Morecambe Offshore Windfarm: Generation Assets Examination Documents

The Applicant's Response to Spirit Energy's Deadline 4 Submission Appendix C: Morecambe Offshore Windfarm / Morecambe Net Zero Interactions Report

Document Reference: 9.59.3

MOWF/MNZ Interactions

Figure 3-5 - Platform and E&A Wells vs MOWF Boundary

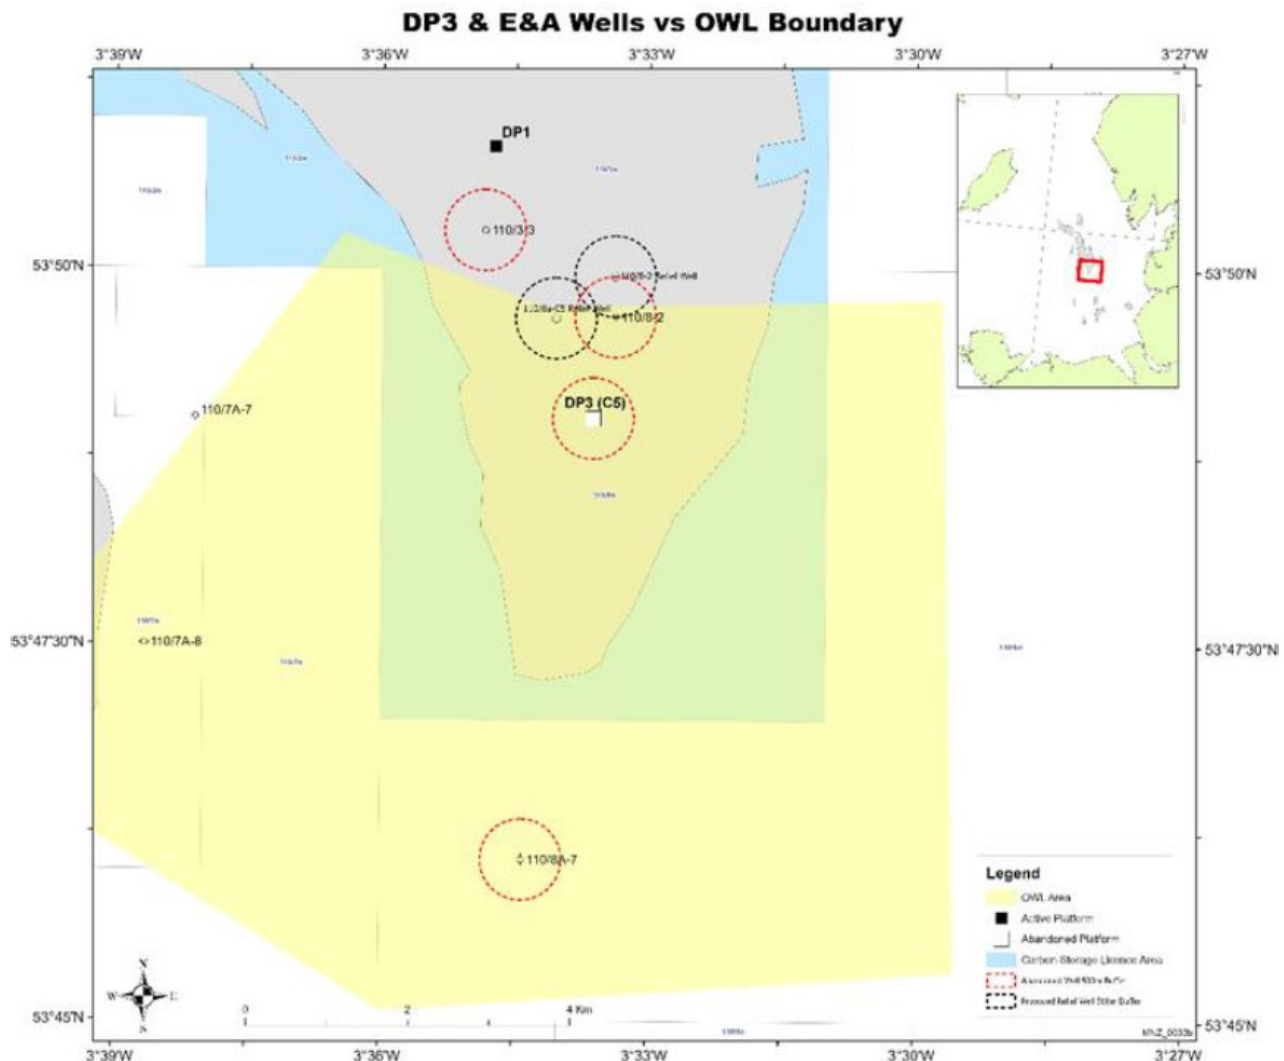
Well 110/8A-7 is the furthest south and in the central southern portion of the wind farm area, as shown in Figure 3-5. It is outside the gas field area (grey polygon on Figure 3-5) and therefore was drilled into the aquifer (i.e. the water-bearing rock that lies below the gas field).

Spirit believes it may need to drill relief wells for the two wells that are on the northern edge of the windfarm area if there is any leakage from them. These are wells C5 (drilled from decommissioned DP3) and appraisal well 110/8-2 (Figure 3-5). The comment that Spirit thinks these may need relief wells indicates that there is some problem with

how the wells were abandoned, contrary to what Spirit has said elsewhere. If this is the case, then the North Sea Transition Authority (NSTA) may require Spirit to take some intervention to abandon them properly even if there was no CCS project. This could be done before the construction of the wind farm starts.

Spirit says they need a 500m exclusion zone around any jack-up rig. The currently planned tophole locations of the possible relief wells appear to be within the Applicant's proposed exclusion zones and approximately 500m or more from the edge of those zones. There should also be some flexibility in where the tophole locations of the relief wells are located to ensure they are a sufficient distance from the nearest WTG. So in the case where relief wells need to be drilled after the wind farm is constructed, it appears that this should be possible.

Figure 3-6 - Cross-Section Through MNZ Storage Complex (Modified after Ref A3)

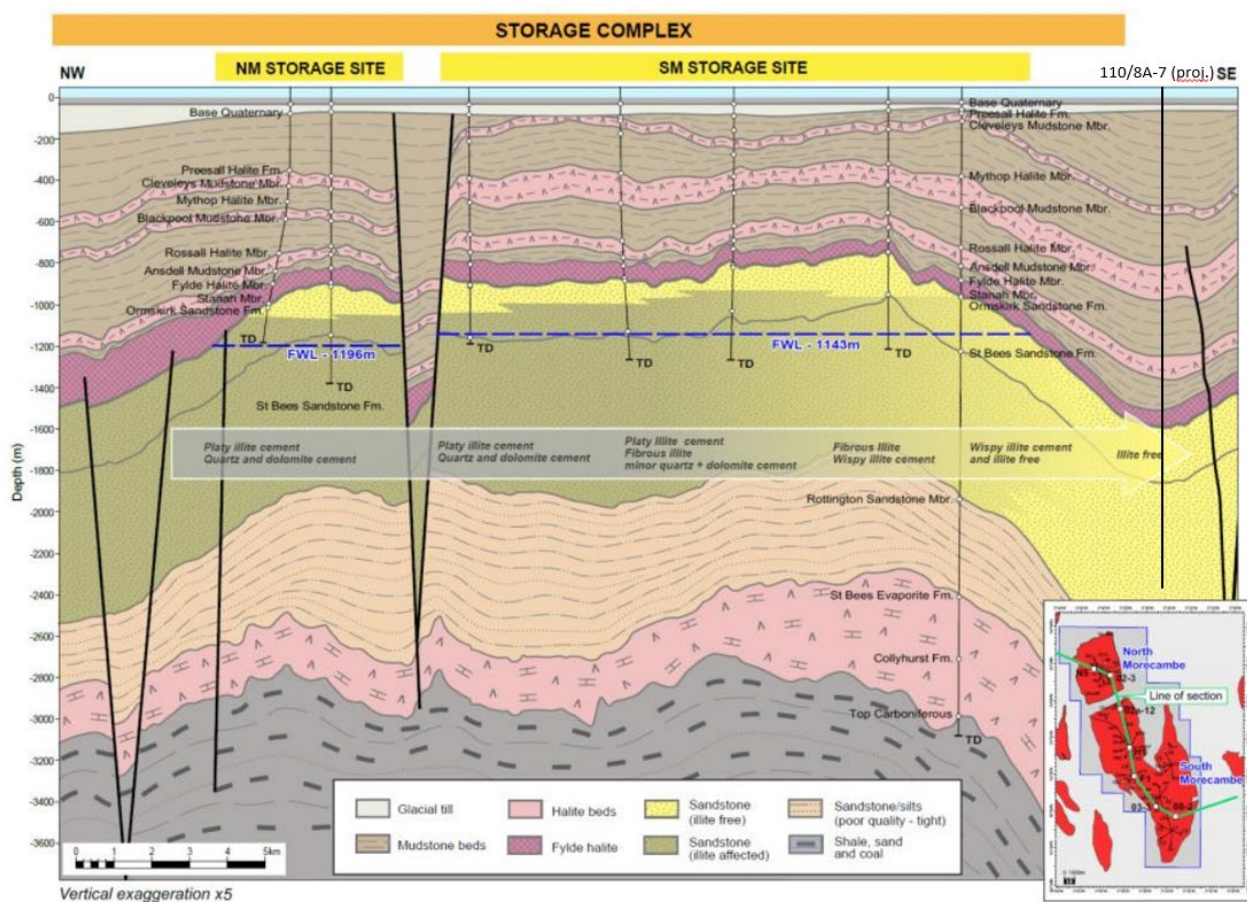
Figure 3-6 is from Ref A3 and shows a northwest-southeast cross-section through the MNZ storage complex. We have projected the approx. location of the southernmost 110/8A-7 well onto the section (the well actually lies further to the south than shown here). The blue dashed line on Figure 3-6 is the FWL (free water level). Above this line is the rock that was originally gas-bearing and has now been depleted by production. Below this line is the aquifer i.e. rock that is water-bearing. As can be seen from the yellow bars across the top of Figure 3-6, the extent of the storage site corresponds with the extent of the original gas field i.e. that volume of rock above the FWL. The storage complex (orange bar on Figure 3-6 and the blue polygon on Figure 3-5) extends slightly beyond the storage site, but does not extend as far as 110/8A-7. CO₂ will be injected into the originally gas-bearing, and now depleted rock, above the FWL. In order for injected CO₂ to reach 110/8A-7, the pressure in the storage site would

have to increase significantly and force the CO₂ below the FWL and move downdip towards the 110/8A-7 well. As the current reservoir pressure is extremely low and is not expected to increase significantly during the injection phase, this scenario is virtually impossible. Therefore Xodus considers it extremely unlikely that any CO₂ would reach well 110/8A-7, and no change in pressure is anticipated at this well. So, if this well has been properly abandoned (as Spirit state it has) then it does not pose any risk. It is located outside the defined storage complex and CS010 licence area and so we can assume no access is required to this well.
